**MUNICIPAL PLANNING COMMISSION
WORK SESSION AGENDA
July 8, 2026, 12:00 pm
Red Bank Court Room
3117 Dayton Boulevard**

Request: Preliminary Design Review for 5010 Dayton Boulevard

DESIGN REVIEW STANDARDS CHECKLIST: 5010 Dayton Boulevard; July 2026

Request: Rezone 3118 Easton Avenue from R-1 to R-T/Z

PRELIMINARY SITE PLAN
DAYTON BLVD SHOPS
5010 DAYTON BLVD,
CHATTANOOGA, TN 37415

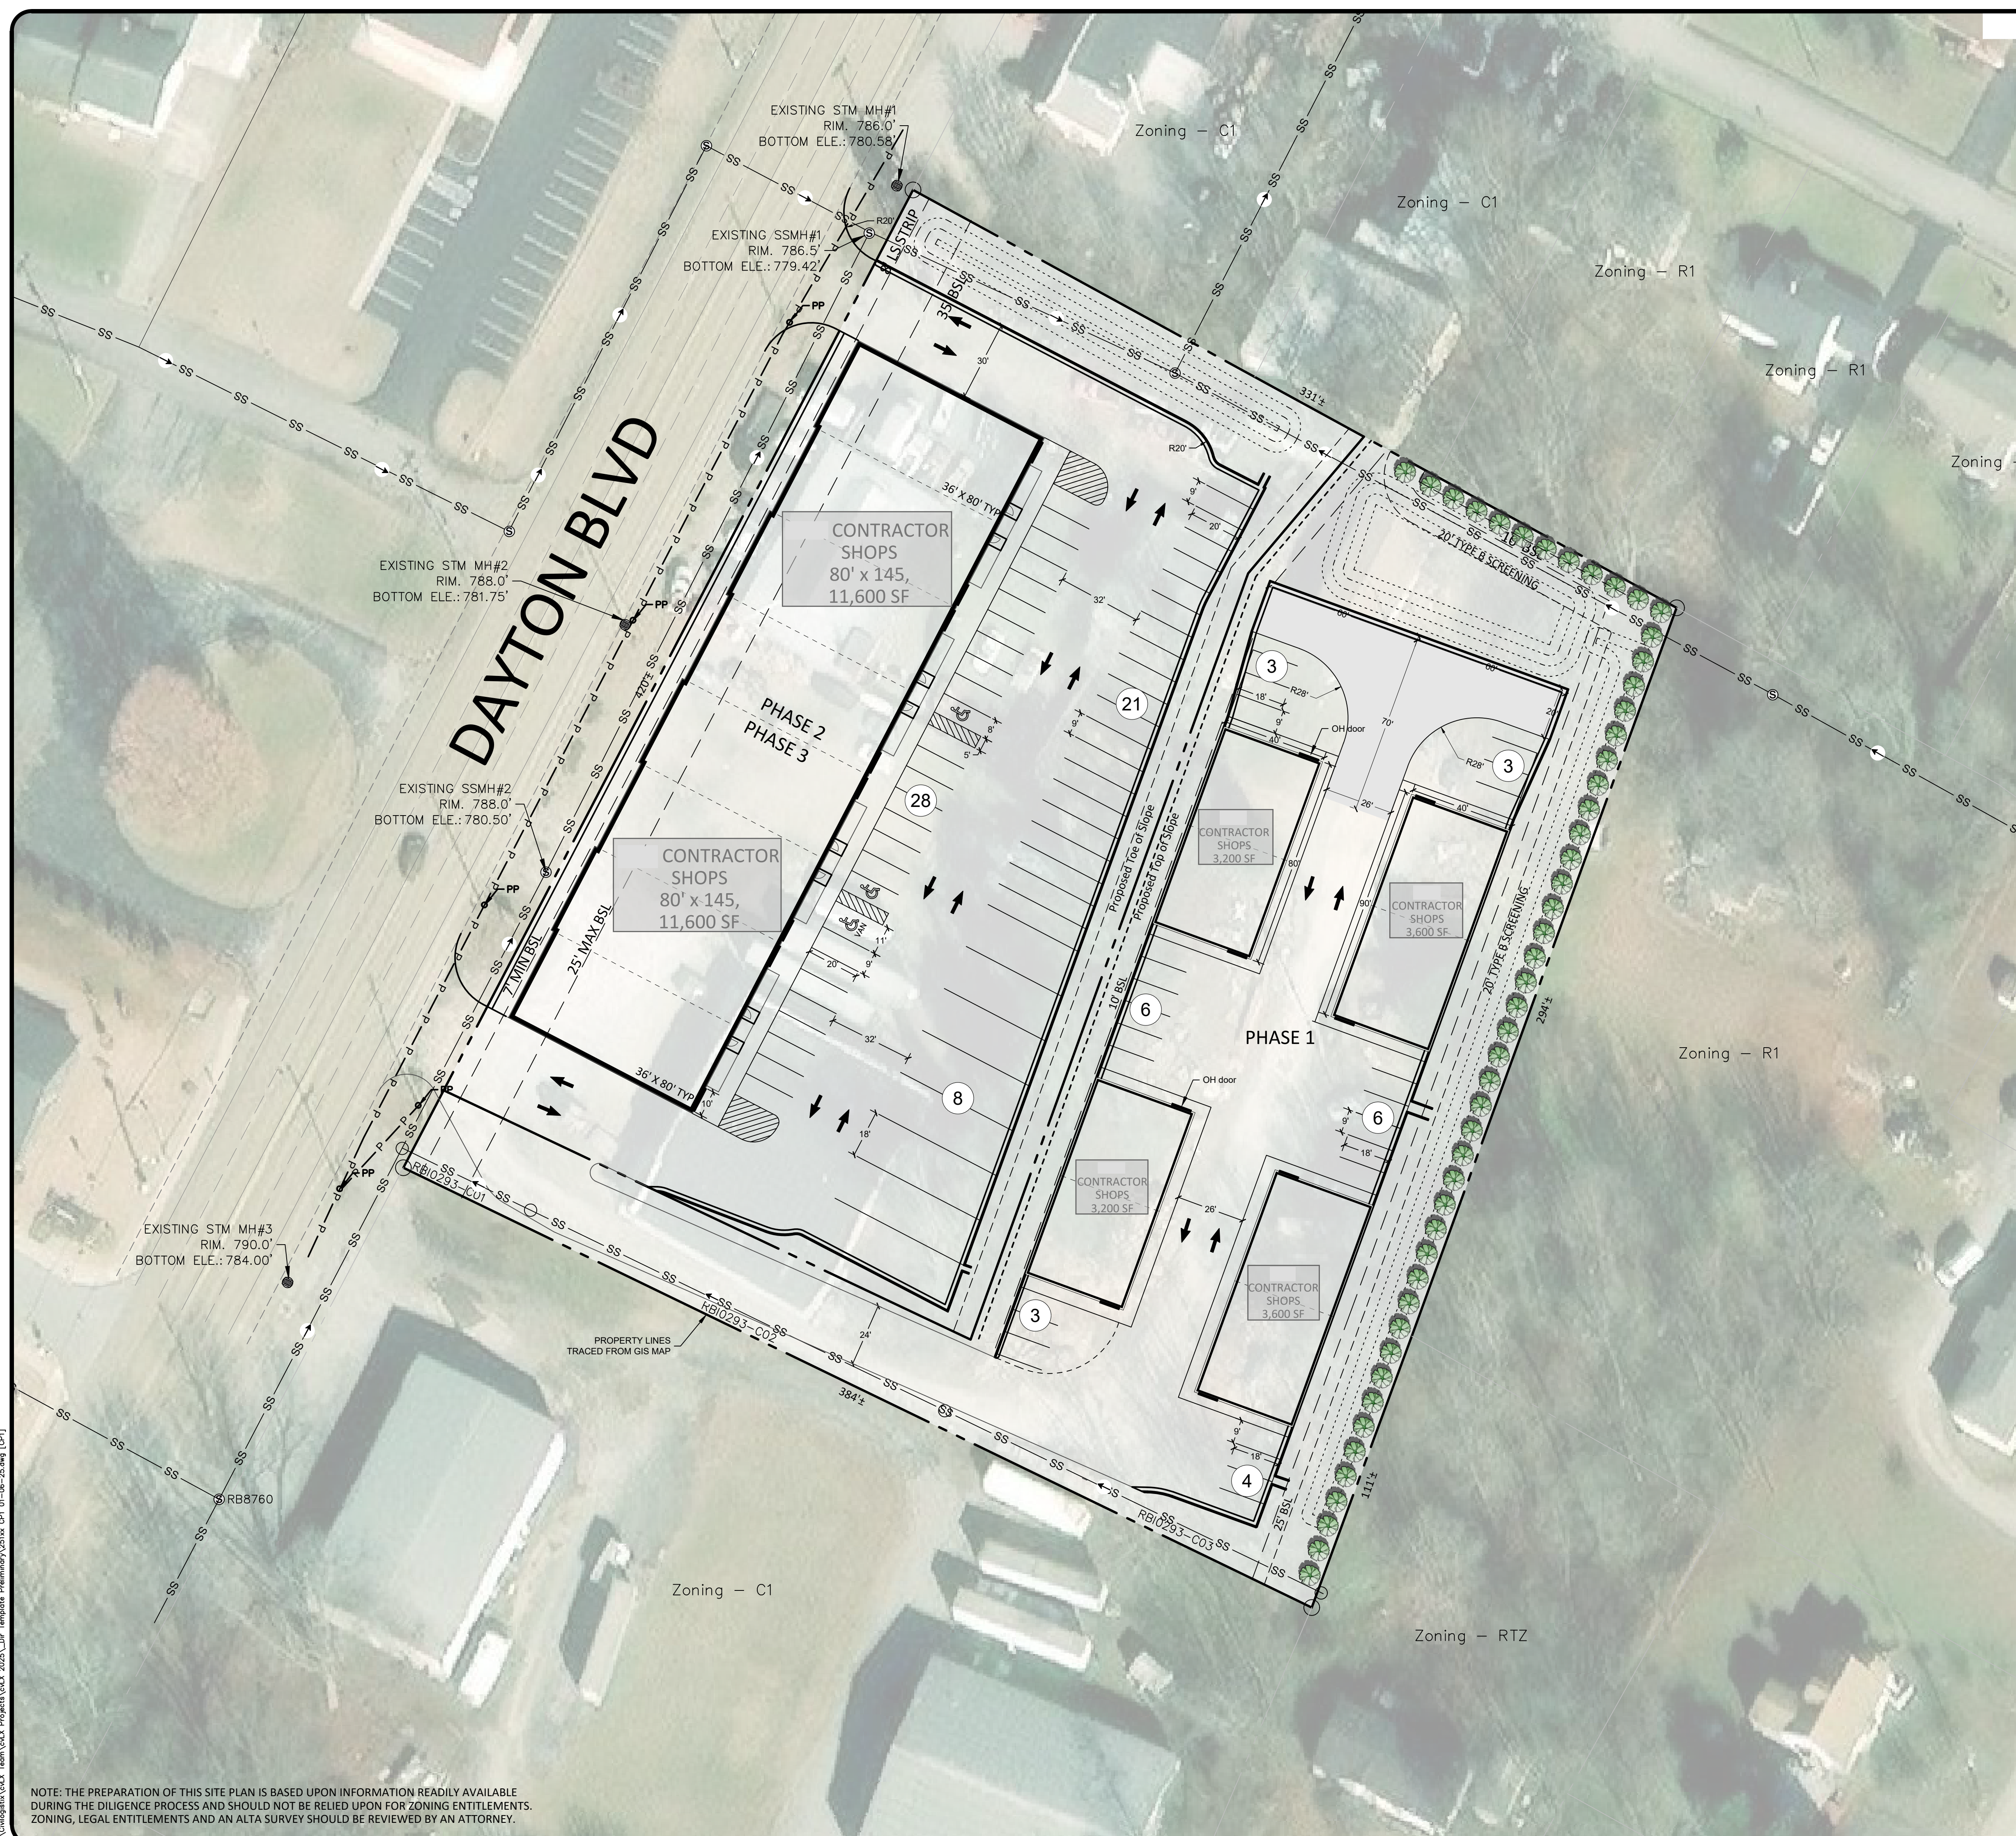
New buildings must be setback zero (0) feet from the back of the sidewalk , unless a Storefront area with a maximum width of eight (8) feet is provided between the Sidewalk and the Building Zone.		N/A
		For any building adjacent to a public street, a primary pedestrian entrance shall be provided that is easily visible from the public right-of-way. If the building has more than one side adjacent to a street, such as a corner-lot building, only one side of the building facing the street is required to have a pedestrian entrance.	No pedestrian entrance shown	N

Element	Exceptions and Notes	Design Standard	Description	Y/N
Building Façade	<p>Complete metal buildings must be approved by both the Planning Commission and Board of Commissioners.</p> <p>Building facades should be designed for compatibility with other adjacent structures located close to the street.</p>	<p>Facades visible from the public right-of-way shall include two or more of the following architectural features:</p> <ul style="list-style-type: none"> a. awning, canopy or marquee, b. balconies, c. projecting cornices, d. recessed entrances or bays, e. arcades, f. wall mural, or g. Other architectural elements approved by the Planning Commission or City Manager. 	Façade not proposed	N
		<p>No single approved material (excluding glass) shall exceed seventy (70%) percent of the exterior building wall(s) that is visible from a public right-of-way and shall be comprised from the following alternative materials: factory-primed fiber-cement lap siding, glass, brick, stone, hard coat stucco, pre-cast concrete, architectural metal panels, and faux stone, and other materials as approved.</p>	Façade not proposed	N

Element	Exceptions and Notes	Design Standard	Description	Y/N
Façade Transparency	Specific alternative designs may be approved by the Planning Commission or City Manager.	Retail Buildings: façades facing the public right-of-way shall have at least thirty percent (30%) of the façade area comprised of clear vision glass at the ground level	Façade not proposed	N
	Tinted or reflecting glass is discouraged.	Non-Retail Building: façades facing the public right-of-way shall have at least twenty percent (20%) of the façade area comprised of clear vision glass	Façade not proposed	N
Massing	Articulation not required for facades less than 30 feet or not visible from the right-of-way. Horizontal articulations in buildings, such as building step-backs or rooftop balconies, are encouraged.	Façades longer than thirty (30) feet and visible from public right-of-way shall be broken down into smaller units through the use of articulation. Articulation may include: a. offsets, b. recesses, c. staggered walls, d. stepped walls, e. pitched or stepped rooflines, f. overhangs, or g. other elements of the building's mass.	+/-290' building width; unknown articulation dimension proposed	Y

Building height shall be compatible with the height of neighboring buildings that are built close to the street.	Building height not shown	N
Roof Expression	Multi-family developments are exempt from Roof Expression standards. Residential roof styles, including hipped and gabled roofs are discouraged.	Buildings should include extended parapets, projecting cornices, or similar features that define the top of the building and create a prominent edge when viewed against the sky.	Roof not shown	N

Element	Exceptions and Notes	Design Standard	Description	Y/N
	Active roofs with gardens and outdoor seating are permitted. Parapets should be extended and embellished.	Mechanical equipment located on roof tops shall be screened from the public right-of-way.	None shown	N

Element	Exceptions and Notes	Design Standard	Description	Y/N
Parking Lot Landscaping	Applies to <u>all</u> commercial zones.	Minimum of one (1) tree for every twenty (20) spaces.	None shown	N
	Parking lots with fewer than 50 spaces are exempt.	Adjacent aisles shall be divided by landscaped islands that that break parking areas into blocks to the extent possible.	None shown	N
		Parking lot landscaping should incorporate best management practices (BMPs) for storm water and other green infrastructure into the design are encouraged to reduce storm water runoff and pollution. Applicants should refer to the Hamilton County Water Quality Manual for guidance on appropriate storm water BMPs for their site.	None shown	N
Parking Lot Lighting	Existing lighting structures, fixtures and bulbs are exempt from these standards.	All New lighting fixtures and bulbs shall be LED, shielded if necessary, equipped with refractors, or placed indirectly to prevent stray upward light or direct light causing glare.	None shown	N

Element	Exceptions and Notes	Design Standard	Description	Y/N
Service Equipment Areas	Applies to <u>all</u> commercial zones. Dumpsters shall be screened according to Screening Requirements found in the Red Bank Zoning Ordinance.	Dumpsters, loading areas, mechanical equipment, outdoor storage areas, and other utilities readily visible from the public right-of-way shall be screened from public view to the maximum extent practicable. Screening shall consist of an opaque wall, fence, or other approved screening method.	None shown	N
	Chain link fences or slats of any material shall not be permitted.	The height of the screen shall be a minimum of six (6) feet, and of such height adequate to completely conceal a dumpster or equipment.	None shown	N
		Screen wall and fence materials shall consist of masonry, stucco, stone, wood, or decorative architectural metal or other approved designs and materials.	None shown	N

Element	Exceptions and Notes	Design Standard	Description	Y/N
Tree Survey / Plan	A tree survey is required when the development will disturb existing vegetation that includes trees larger than 6 inches in diameter.	<p>On sites with existing mature trees, at least a third (33%) of specimen trees shall be preserved or transplanted on site, to the maximum extent practicable. For purposes of this section, "specimen" trees include the following:</p> <ul style="list-style-type: none"> a. Deciduous trees with twenty inch (20") minimum diameter at breast height (DBH) b. Evergreen trees with twenty inch (20") minimum DBH; c. Groups or stands of seven (7) or more trees with a minimum DBH for each tree of six inches (6"). 	Unknown existing vegetation	N
		Specimen trees in appropriate locations, such as along drainages and along the perimeter of the site may be used to fulfill landscaping or buffering requirements under the Design Review Ordinance.	Unknown existing vegetation	N

PROPOSED ZONING

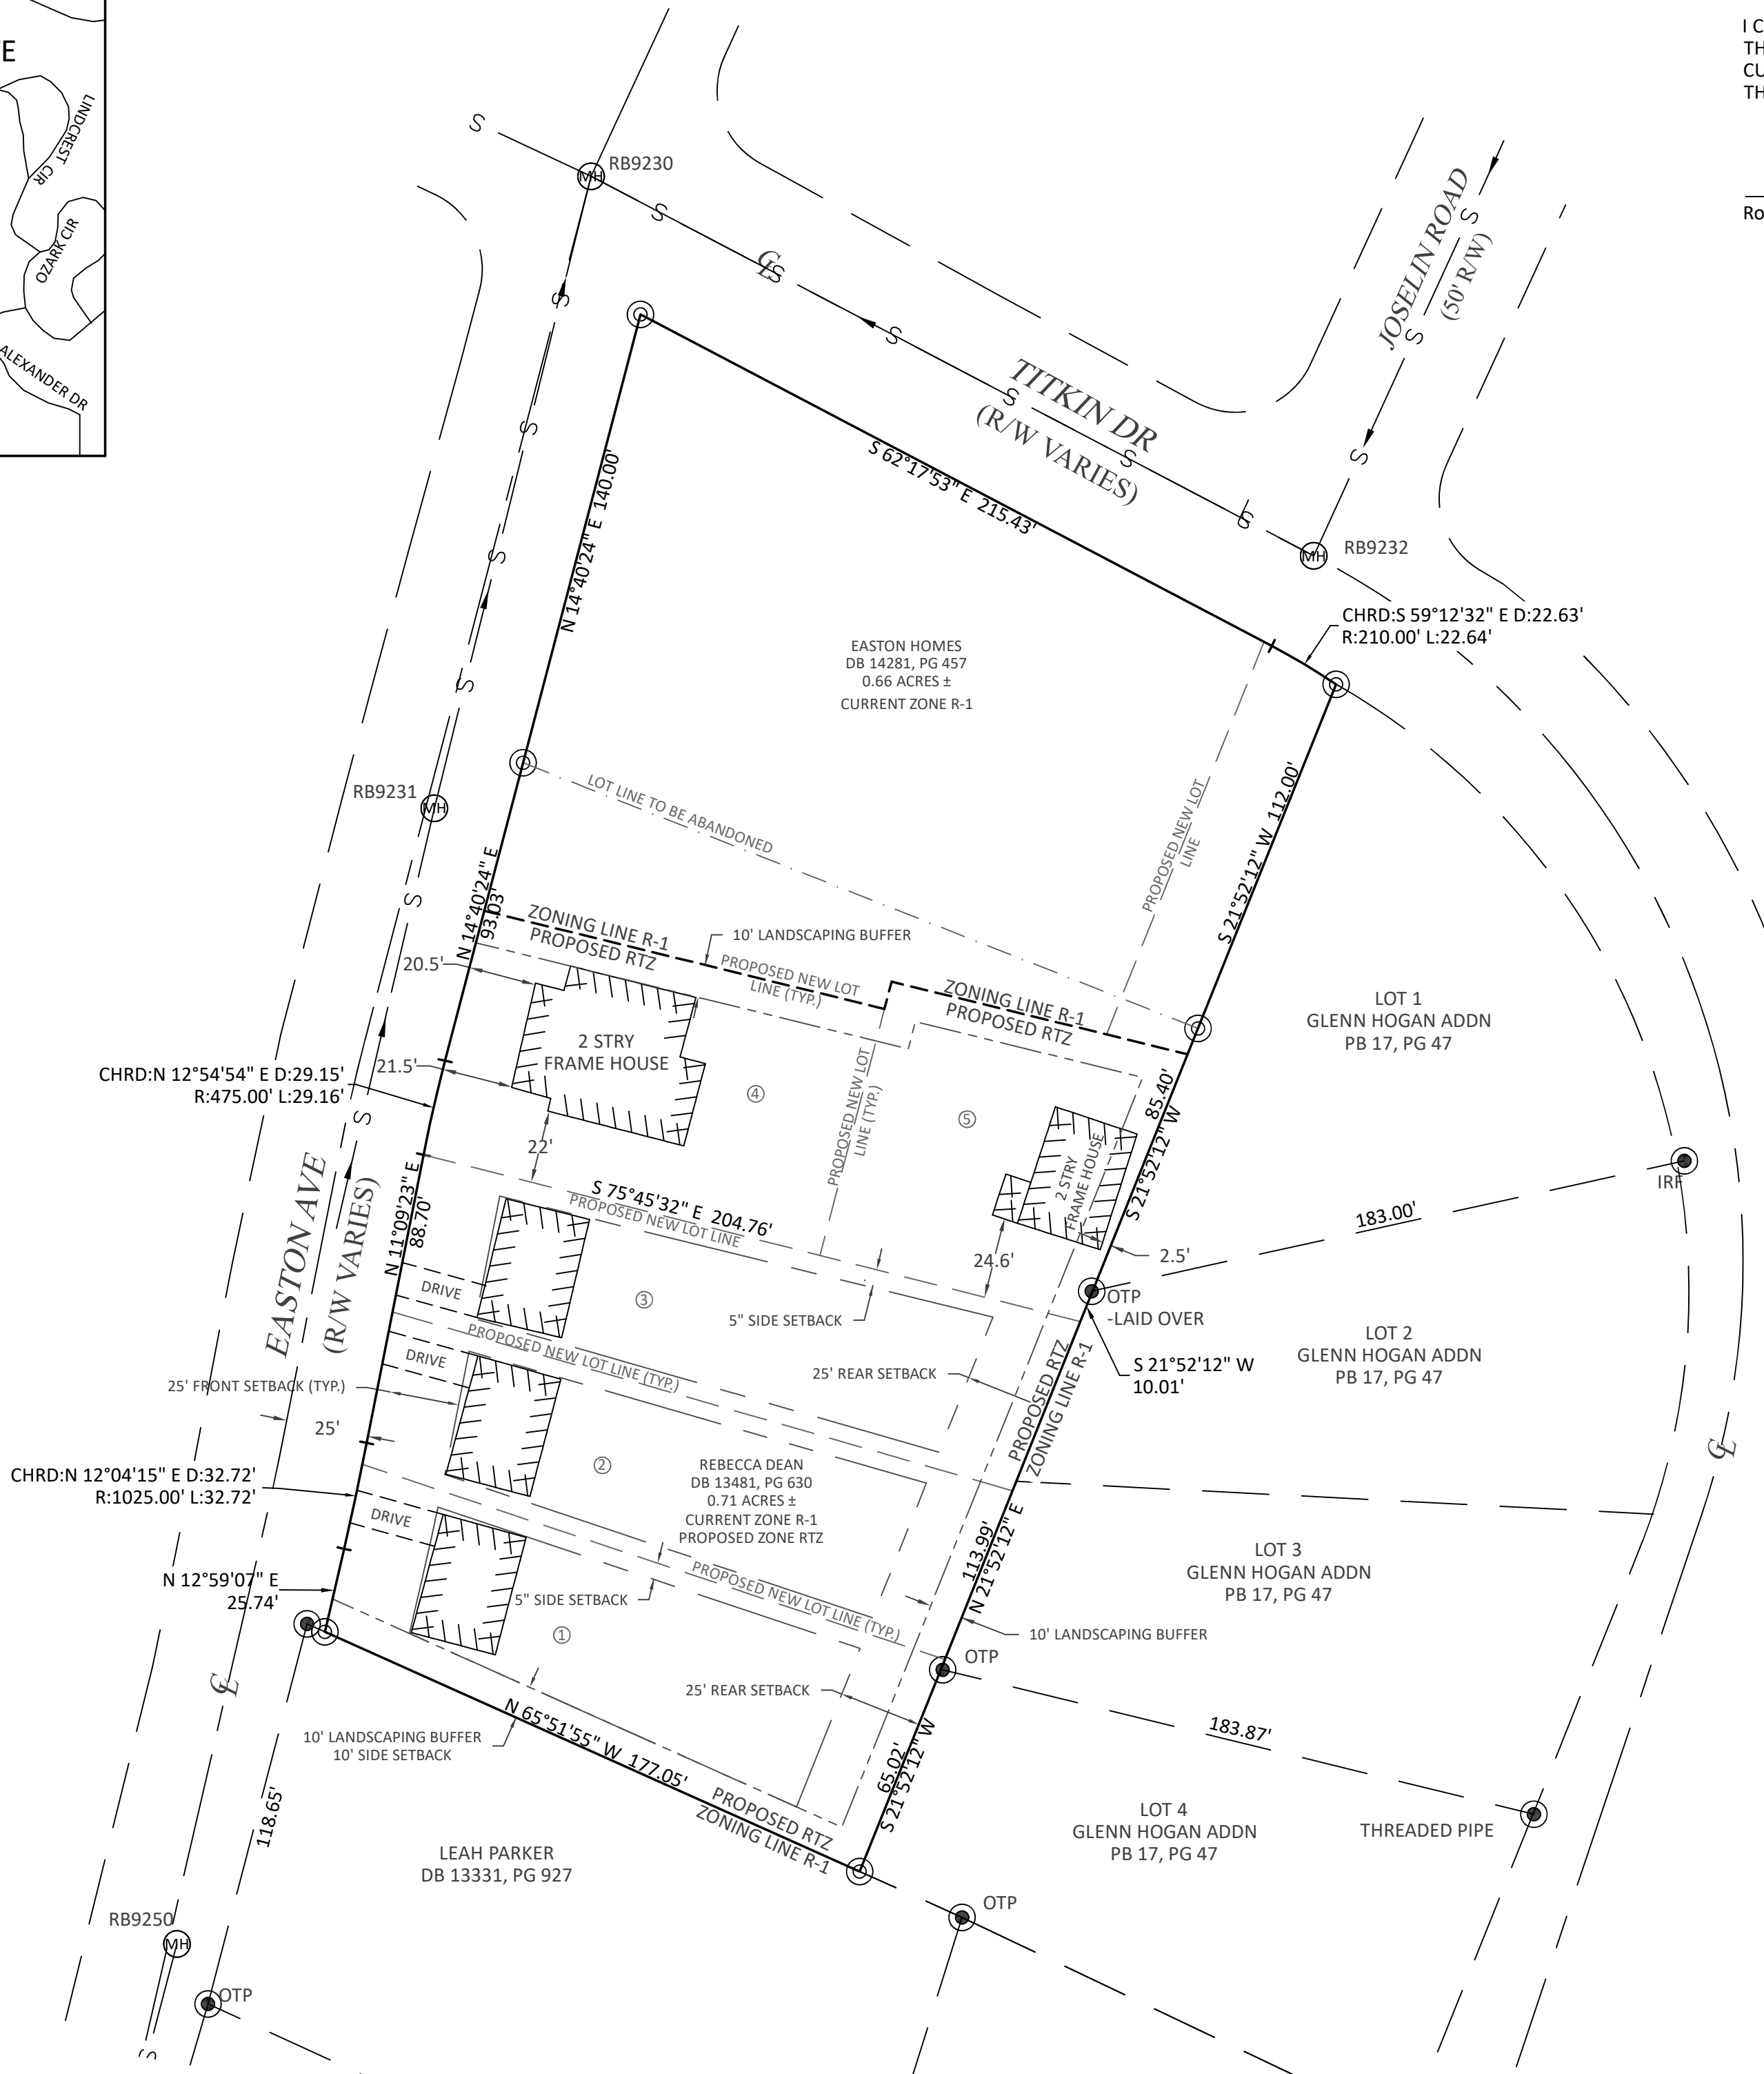
The request is to rezone +/-1.24 acre lot in order to subdivide into 4 lots that are presumably less than 60' wide, but the site plan does not show exact dimensions.

Site access and preliminary street layout: Lots 1-4, Easton Avenue frontage; Lot 5, access not shown.

Type of off street parking: Lots 1-3, drive; Lot 4, not shown; Lot 5, not shown.

Range of lot sizes: Lot 1, not shown; Lot 2, not shown; Lot 3, not shown; Lot 4, not shown; Lot 5, not shown.

All buffer, landscape and screen areas including site specific landscape design: 10' type-c landscape buffer shown, not specific

The proposed site plan meets the density, lot width, front yard setback, and rear yard setback(with the exception of the existing lot 5 structure which would be grandfathered in) requirements. However the proposed site plan does not meet the building separation requirement, 12' from side to side, and side yard setback, 10'.
